County File No. PPR2048

DRAWN BY: D.E. WATTS DATE: 12-4-20 DWG. NO.: 20-5449-04 PERFORMED BY: COUNTY LICENSE SURVEYED BY: DEV. ESW. 4-29-20 12-4-20	APPROVED BY: PROJ. NO.: DWG.	REVISIONS 7-6-21 REVISED PER COUNTY REVIEW DEW 1-26-22 REVISED PER COUNTY REVIEW DEW	OLIVER E. WATTS CONSULTING ENGINEER COLORADO SPRINGS	PROJECT 16965 LINDBERGH ROAD N1/2, N1/2, NW1/4, SE1/4, SEC. 22, T.11S., R.67W. EL PASO COUNTY	SHEET NAME GRADING AND EROSION CONTROL PLAN	SHEET NO. OF 2
---	------------------------------------	---	--	--	---	-------------------

STANDARD NOTES FOR EL PASO COUNTY GRADING AND EROSION CONTROL PLANS

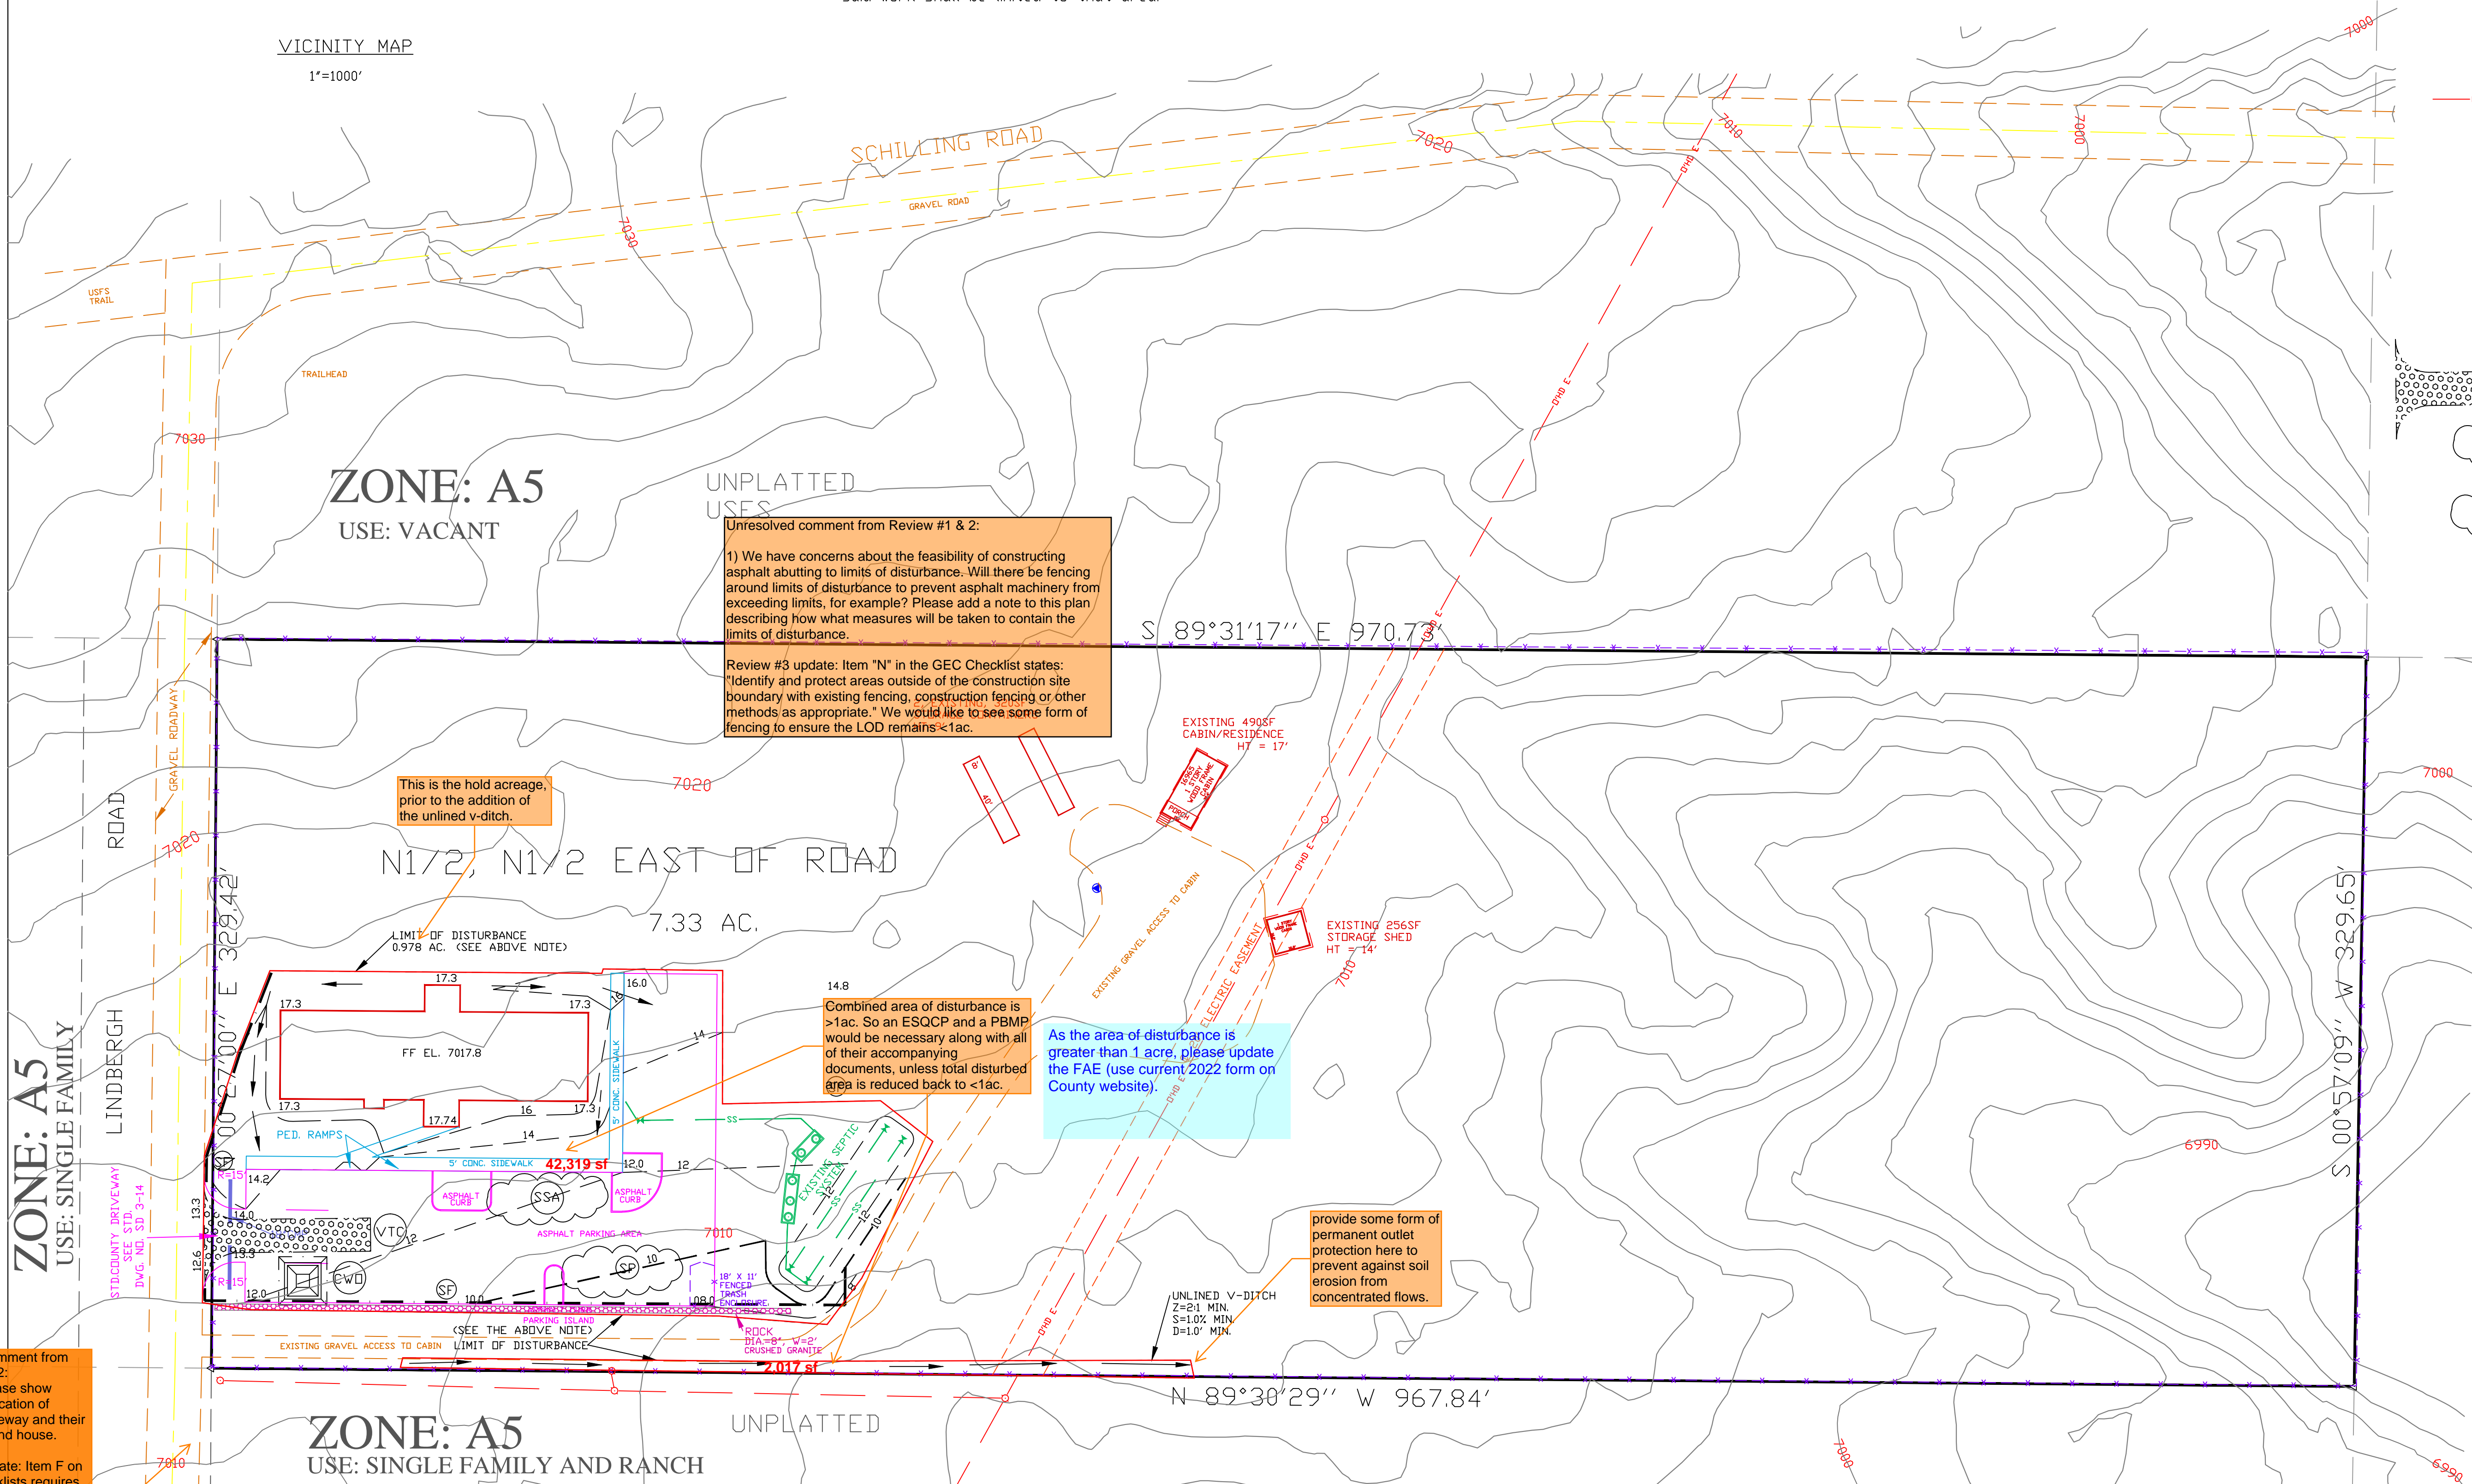
Unresolved comment from Review #1 & 2:
1) We have concerns about the feasibility of constructing asphalt abutting to limits of disturbance. Will there be fencing around limits of disturbance to prevent asphalt machinery from exceeding limits, for example? Please add a note to this plan describing how what measures will be taken to contain the limits of disturbance.

Review #3 update: Item "N" in the GEC Checklist states: "Identify and protect areas outside of the construction site boundary with existing fencing, construction fencing or other methods as appropriate." We would like to see some form of fencing to ensure the LOD remains <1ac.

This is the hold acreage, prior to the addition of the unlined v-ditch.

Combined area of disturbance is >1ac. So an ESQCP and a PBMP would be necessary along with all of their accompanying documents, unless total disturbed area is reduced back to <1ac.

As the area of disturbance is greater than 1 acre, please update the FAE (use current 2022 form on County website).

provide some form of permanent outlet protection here to prevent against soil erosion from concentrated flows.

Unresolved comment from Review #1 & #2:
For clarity, please show approximate location of neighbor's driveway and their existing barn and house.

Review #3 update: Item F on the GEC Checklists requires all existing structures be shown on the GEC Plan. And to properly determine suitability of the outfall location, we need to see where the adjacent structures are to verify that drainage is being directed away from those structures.
